TECHNICAL INFORMATION *((ECHD.)* shindaiwa"

SUBJECT: Carburetor on ECHO CS-4510ES and shindaiwa 451s

Number: Y2019-675(1/2) Issued: Nov. 29, 2019

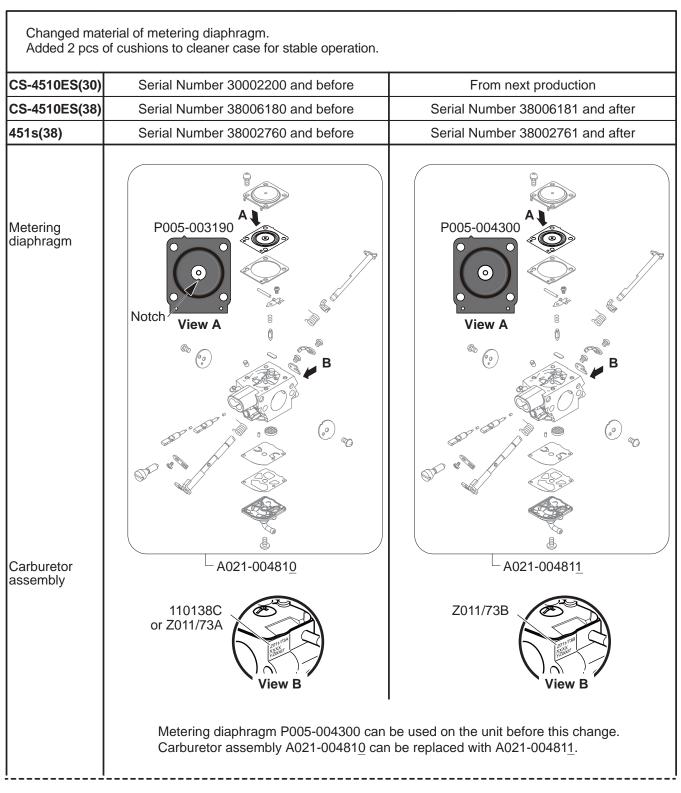
Adding 2 pcs of cushions on cleaner case

1. Pass 2 cushions V420-005260 (A) through 2 ribs (b) of cleaner case (B).

2. Install rib (a) of each cushion (A) in engine cover hole (c).

NOTE: At first, install rib (a) in engine cover hole (c) from clutch drum side to assemble easily.

3. Use flat head screwdriver (D) when it is difficult to install rib (a) of each cushion.

4. Assemble big air duct (E) with small air duct (F). Then tighten 2 torx bolts.

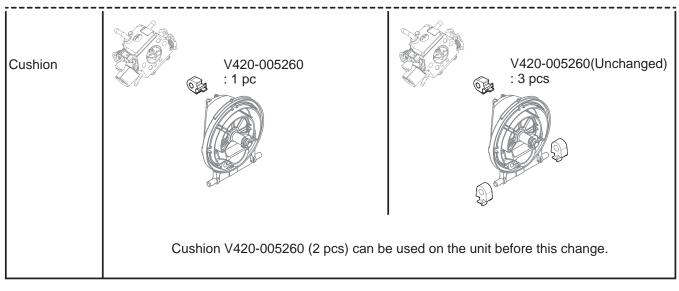
NOTE: Carburetor adjustment procedures are the same.

120186 R1G 120954 R1K
